From:	Rehm, Zach@Coastal <Zach.Rehm@coastal.ca.gov>
Sent time:	08/02/2018 12:56:34 PM
To:	Jill Martin <jmartin@trumpnational.com>
Cc:	So Kim
Subject:	RE: Trump lot D landscape plan
Attachments:	Lot D Landscape Plan 2018.08.02 _ZR comments_Page_2.jpg

TRUMP NATIONAL GOLF CLUB
LOT 'D' PRESERVATION AREA
PLANTING PLAN

DRAWING L1.00
SHEET 2
OF 7

Lot D Landscape Plan 2018.08.02 _ZR comments_Page_2.jpg

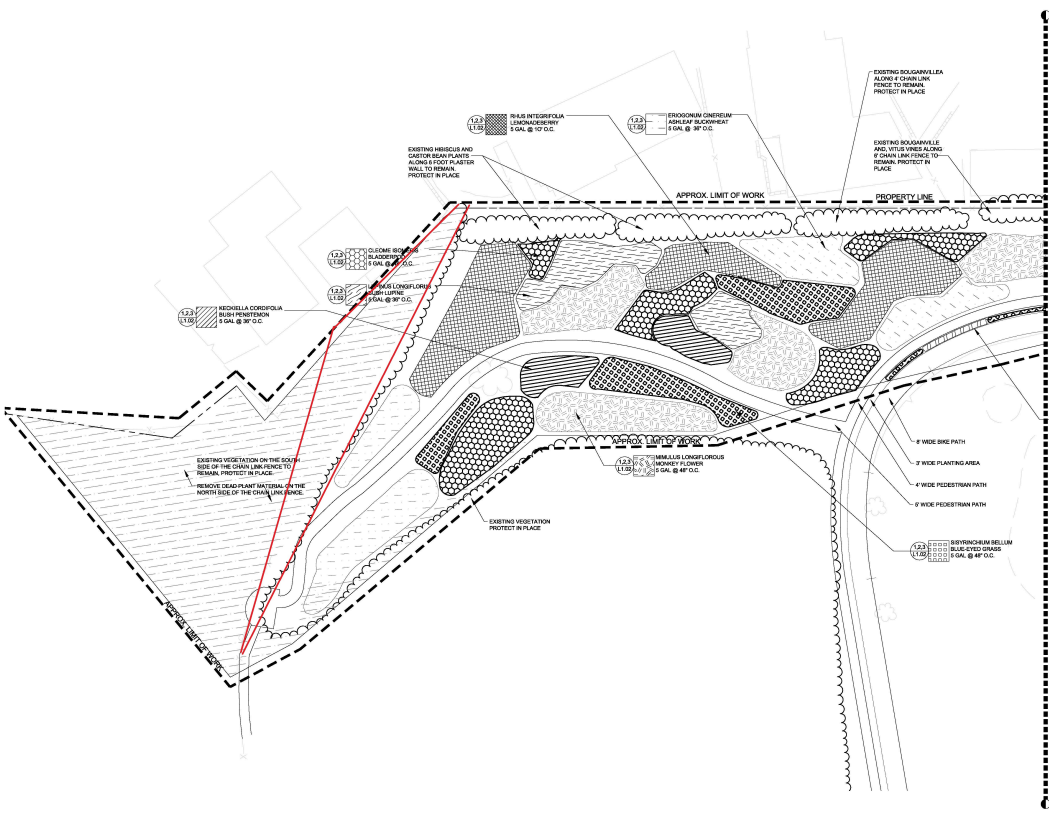
Hi Jill, I am still concerned about the invasive vegetation proposed to remain at the southern portion of Lot D. I understand there is an agreement to retain the vegetation near the private residence, which was the basis for the lot line agreement, and I understand some vegetation south of the chain link fence will be difficult to remove. However, an area at least the size of the red triangle in the attached copy of page 2 of the plan should be replanted with native plants. This is necessary to carry out the requirements of the CDP special conditions to establish at least 1.0 acres of habitat on Lot D and provide a native vegetation buffer between the trails and the residences.
